1 Q. **Reference: Attachment 1- Long-Term Supply for Southern Labrador - Economic and Technical**  
2 **Assessment**

Figure 1: CPV Chart with 20-Year Delay Sensitivity Case

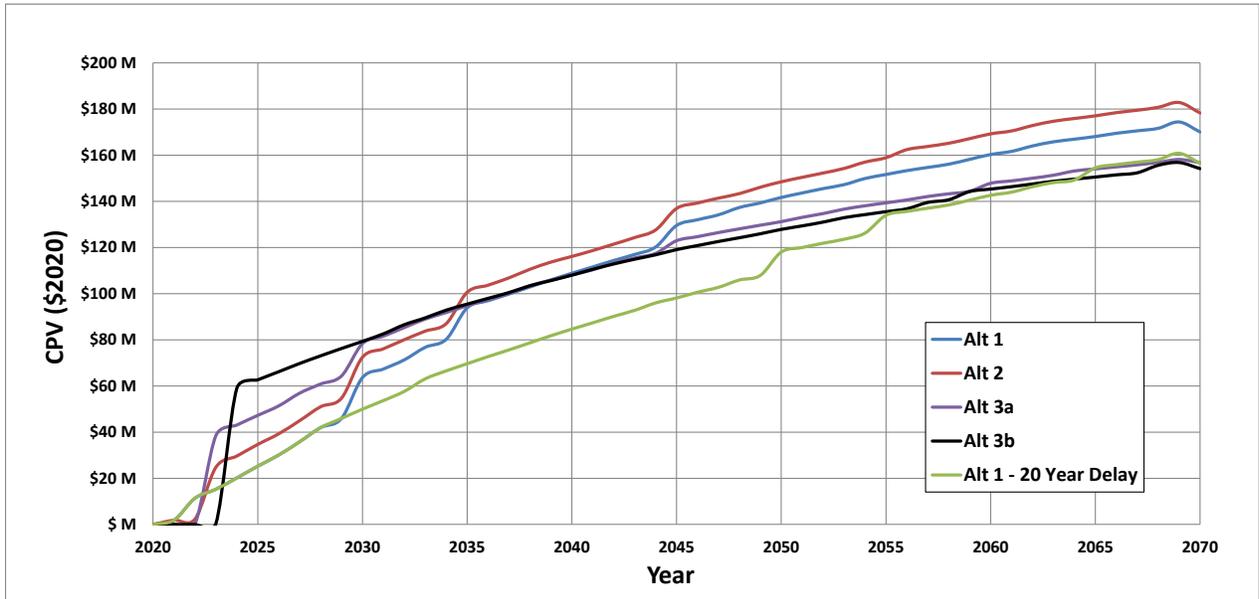
3 Page 42, lines 20-25, states “Case 10 represents a scenario where the continued operation of  
4 mobile units at the Charlottetown Diesel Generating Station would be preferred if all diesel  
5 generating station replacement costs could be reduced by 80%. Reliable operation with such a  
6 significant reduction in expected capital expenditures is deemed to be unsustainable. Further  
7 analysis indicates that even if diesel generating station replacements are deferred by more than  
8 20 years, the interconnected alternatives remain the most economic solution.” Please provide  
9 the above-referenced ‘further analysis’.

12 A. The further analysis described in the citation consisted of a high-level cost-benefit sensitivity  
13 review where Alternative 1 (the mobile option) was modified with plant replacements for  
14 Mary’s Harbour, Port Hope Simpson, and St. Lewis each delayed by 20 years. For the purposes of  
15 simplicity in this cursory review, operating and maintenance (“O&M”) costs were not increased,  
16 despite the 20-year replacement delays for these facilities. All other parameters in the analysis  
17 were also held constant.

18 The results of this analysis are provided below in Figure 1. As illustrated, the interconnected  
19 alternatives remain the least-cost solutions by the end of the study period.

20 While a detailed assessment of the impacts of delayed plant replacement on O&M costs was not  
21 performed, such impacts would likely result in significant cost increases. Further, such delays  
22 would be expected to result in appreciable reliability impacts.
